**TOWN OF NEWBURGH
PLANNING BOARD
TECHNICAL REVIEW COMMENTS**

PROJECT NAME: HILLSIDE LAND DEVELOPMENT
PROJECT NO.: 22-27
PROJECT LOCATION: SECTION 34, BLOCK 2, LOT 66/24 JEANNE DRIVE
REVIEW DATE: 9 JUNE 2023
MEETING DATE: 15 JUNE 2023
PROJECT REPRESENTATIVE: FELLENER ENGINEERING, LLP

Subject: Hillside Land Development #2022-27
Jeanne Drive, Newburgh, NY
Fellenzer Engineering Project 19-049

Please find attached proposed site plans in regards to the above referenced project. We have received the MHE technical review comments dated 04/28/23 and offer the following responses in italics below:

2 DETENTION POND OUTLET STRUCTURE
N.T.S.

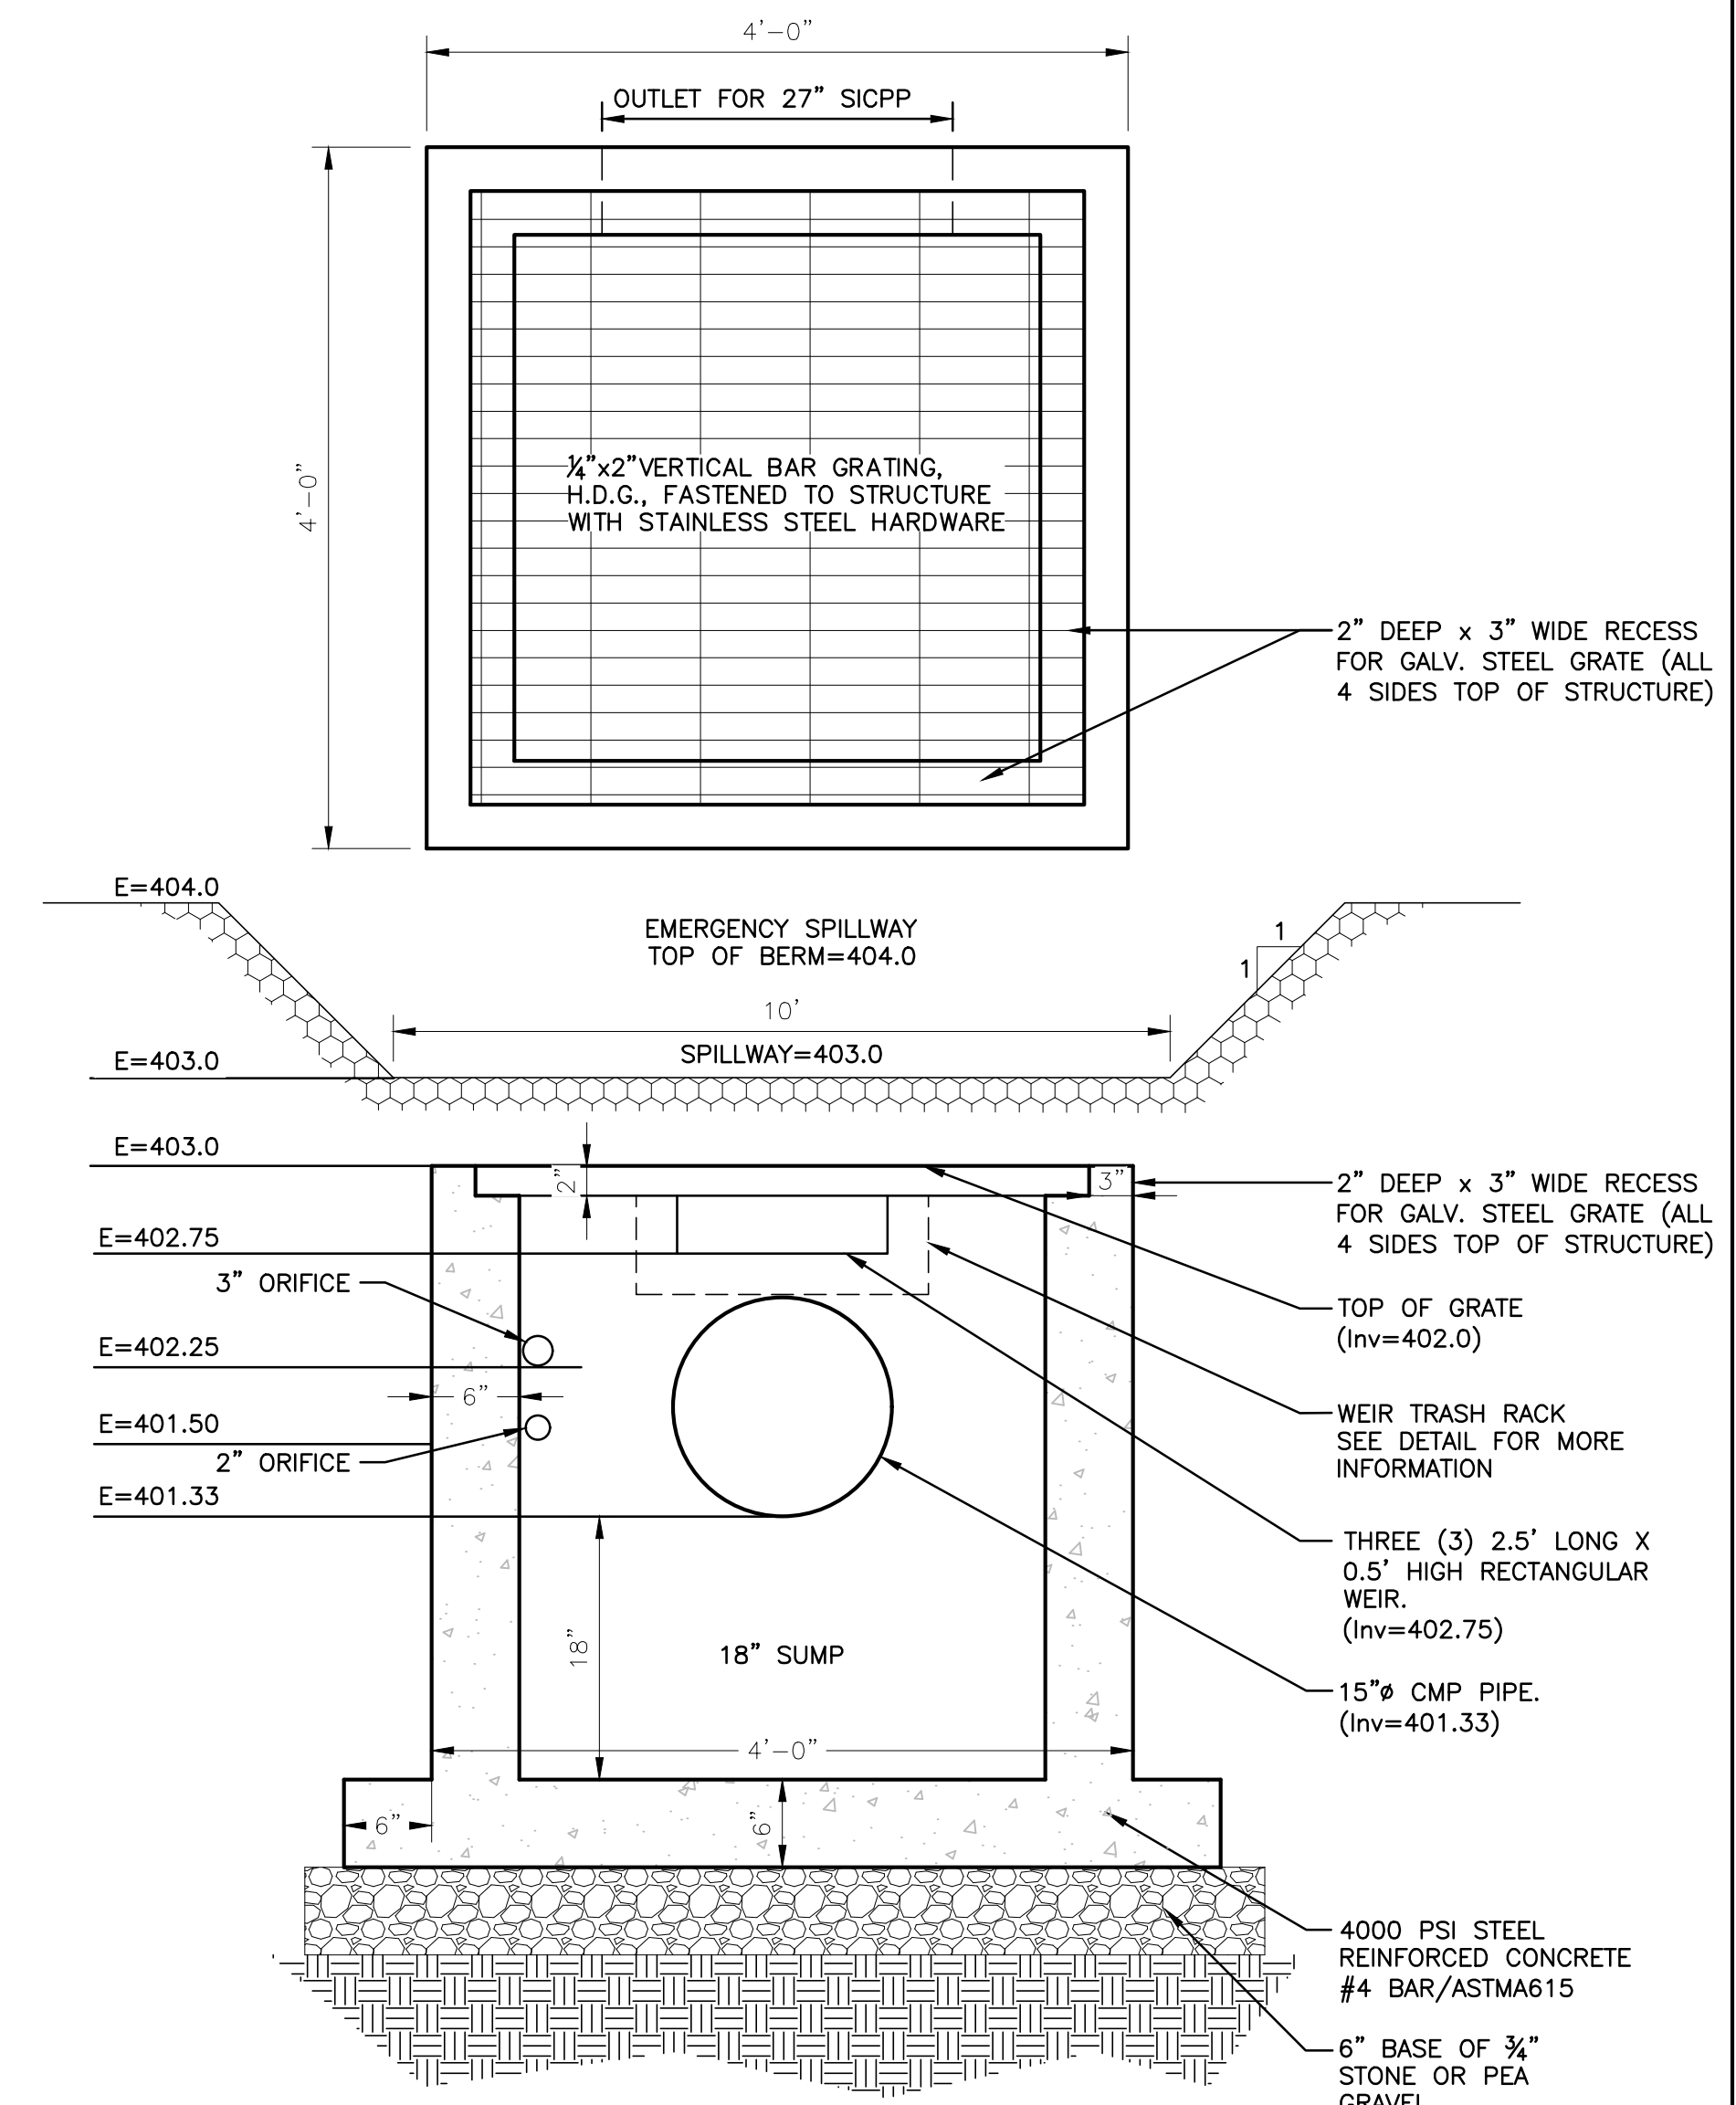
7. The outlet location for the pocket pond should be depicted on the plans. It is unclear where on the plan the 399 and lower elevation exists.

3. Similar comments for the retention pond outlet structure detail identifies the invert for the 15-inch discharge pipe at 399.0, while the model identifies it at 399.83. The first 3-inch vertical orifice is identified at 399.0 while it is not included in the model.

FE Response: The outlet is shown on stormwater pond and the elevation has been adjusted to match existing topography.

FE Response: The inverts have been updated in the plans to reflect the same elevations in the Stormwater Management Report.

4 CULTEC CHAMBER OUTLET STRUCTURE
N.T.S.

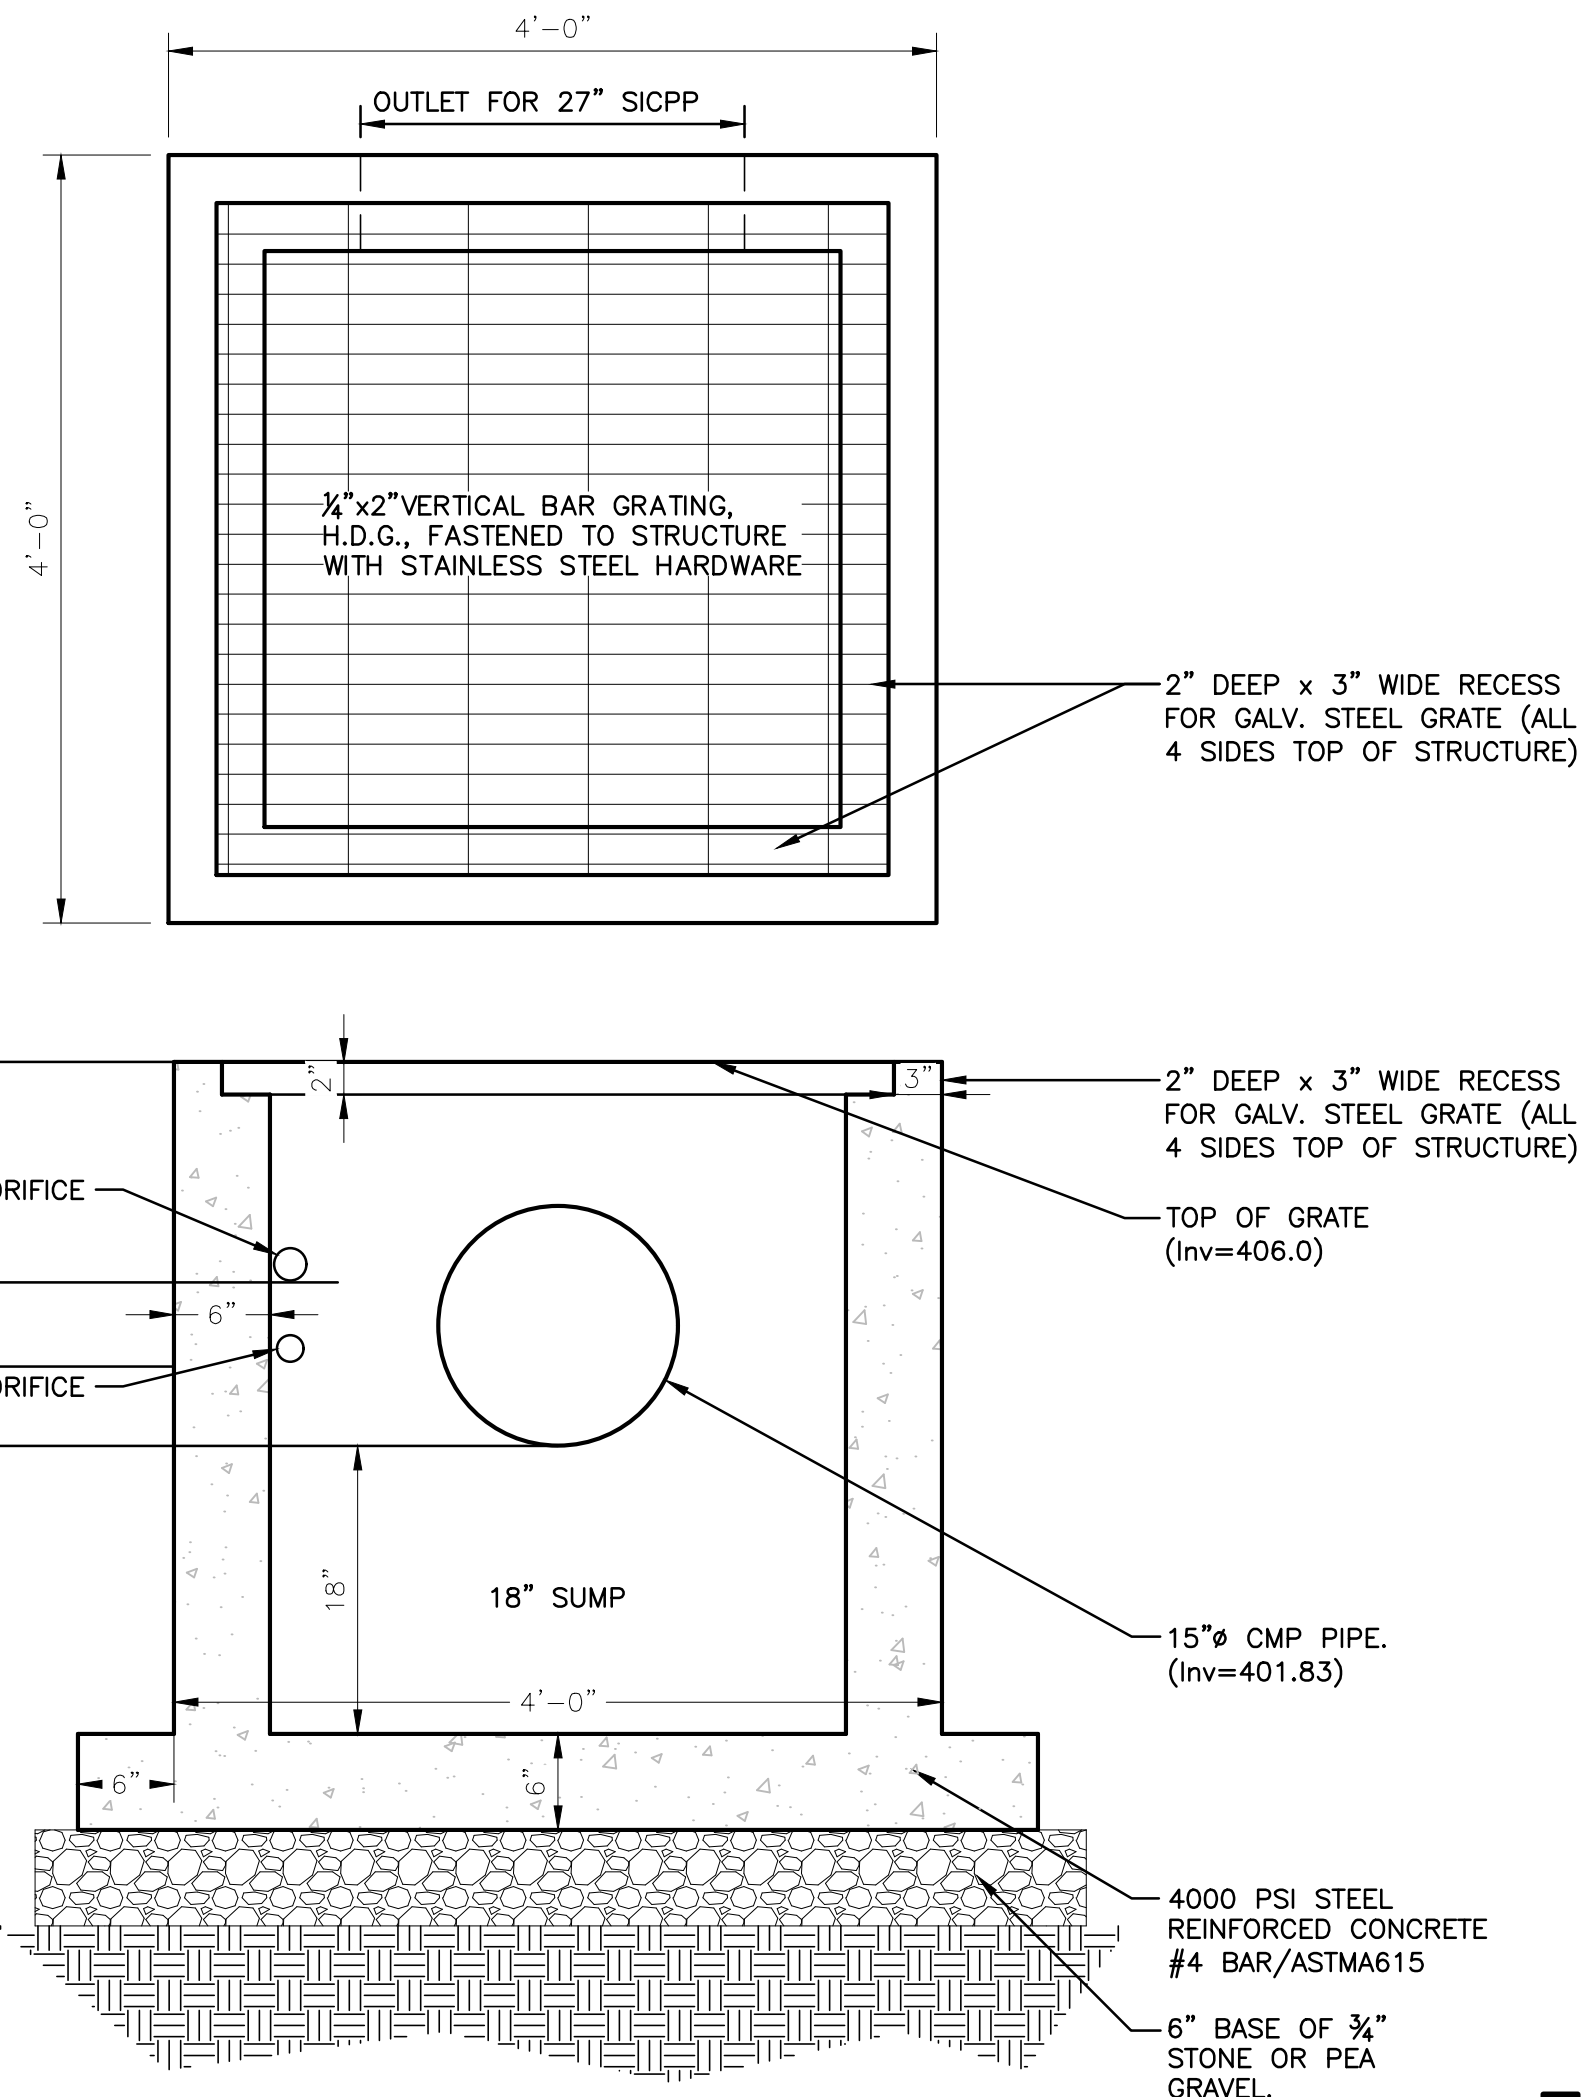
6. The outlet for the Cultech storm tech chambers should be labeled on the plans.

1. The applicant's representative are requested to coordinate the Cultech Chamber outlet structure with the inverts and discharges within the Stormwater Management Report. Primary invert for the Cultech Chamber is identified at 401.83, the plans identify it at 400.

2. A 3-inch vertical invert at elevation 400 is depicted on the plans, however not modeled in the control structure. It is unclear from a review of the plans where the influent to the Cultech system is.

FE Response: The outlet for the Cultech chambers has been added on sheet C-402.

FE Response: The inverts have been updated in the plans to reflect the same elevations in the Stormwater Management Report.

FE Response: The 3-inch vertical invert has been removed from the plans.
